Regulation 12 of Annex I MARPOL
Amended requirements for sludge discharging piping and
bilge-water piping

ClassNK

Technical Information

No. TEC-1080
Date 2 August 2016

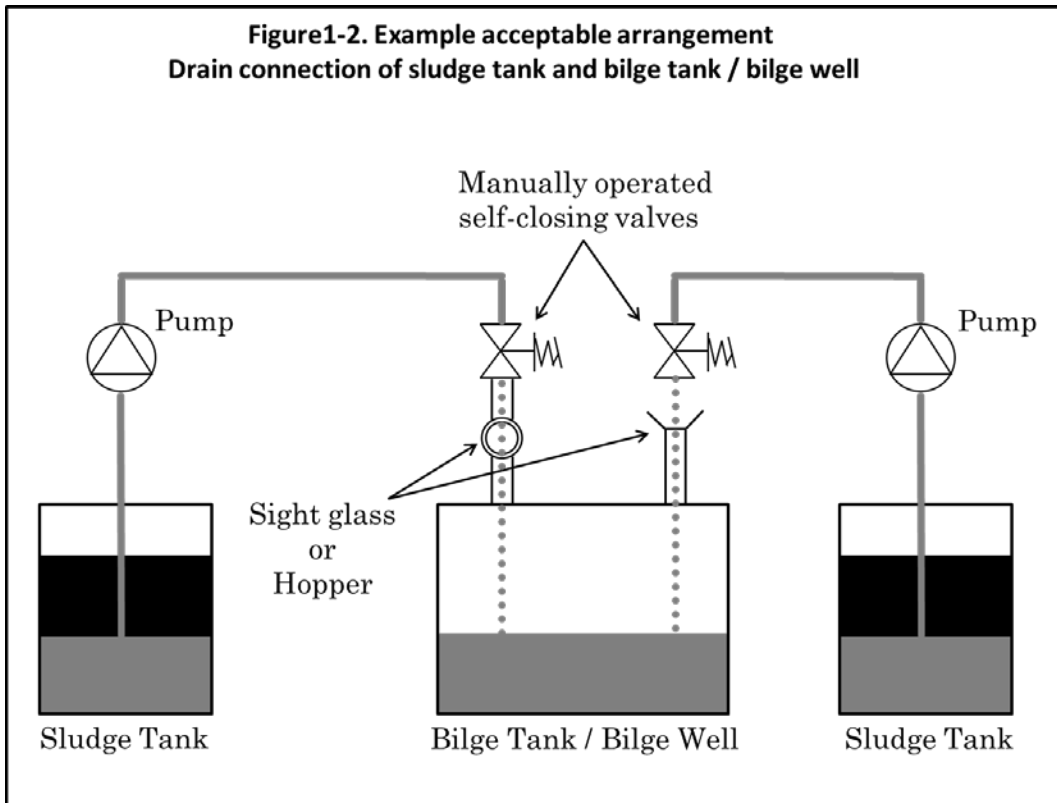
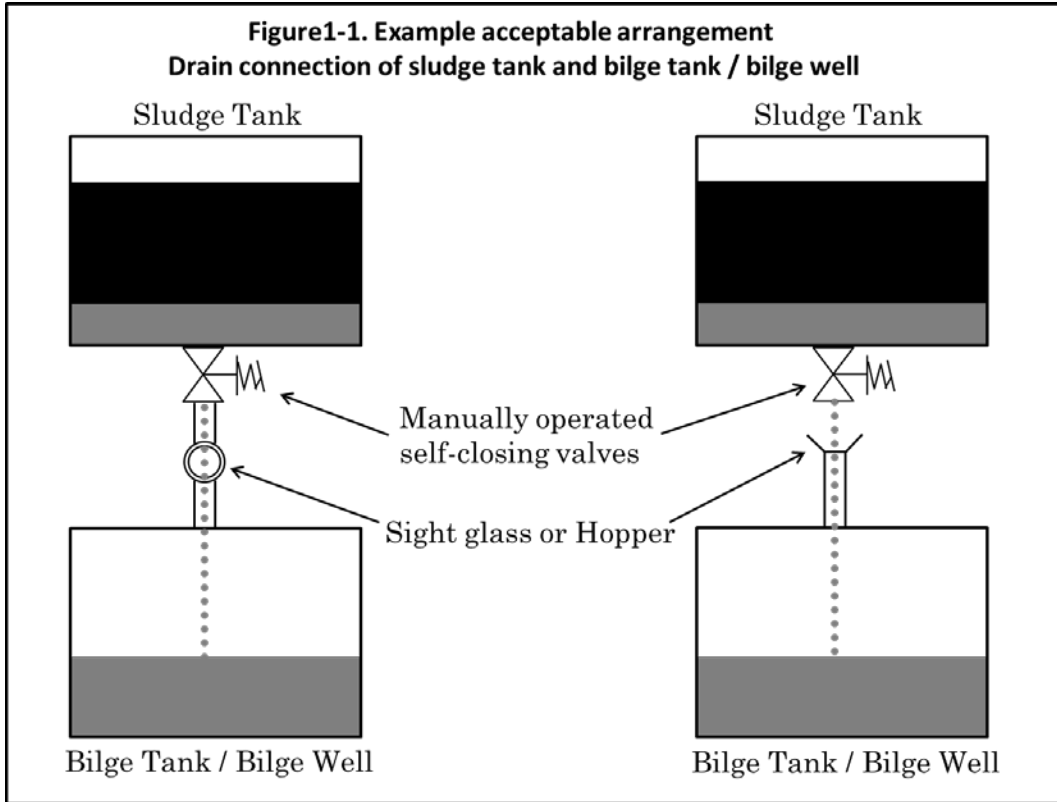
- (1) The sludge tank(s) may be fitted with drains, with manually operated self-closing valves and arrangements for subsequent visual monitoring of the settled water, that lead to an oily bilge water holding tank or bilge well, or an alternative arrangement, provided such arrangement does not connect directly to the bilge discharge piping system. (Refer to figure.1 in Attachment No.1)
